PLANNING COMMISSION STAFF REPORT FEBRUARY 20, 2020

AGENDA ITEM 7.A File No. PL19-0123 – **STANLY RANCH RESORT PHASE 2**

PROJECT SUMMARY: Design Review Permits and Tentative Subdivision Maps for Phase 2 of the Stanly Ranch Resort

FIGURE 2 – TENTATIVE SUBDIVISION MAP VINEYARD HOMES

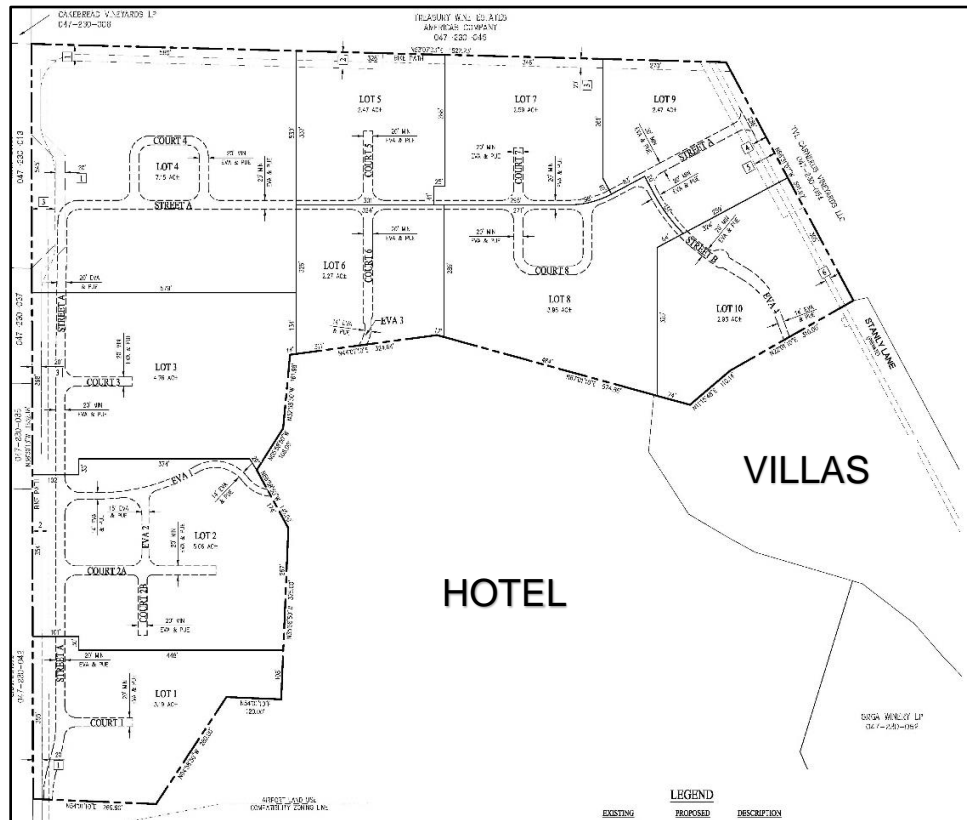
The Phase 2 application includes a Tentative Subdivision Map to subdivide the 36.85-acre Vineyard Home portion of the development (APN 047-230-059) into ten lots. These 10 lots would then be developed with 70 residential condominium units consistent with the table below:

The proposed Vineyard Homes Tentative Subdivision Map is consistent with the Unified Site Development Plan that was approved by the City Council.
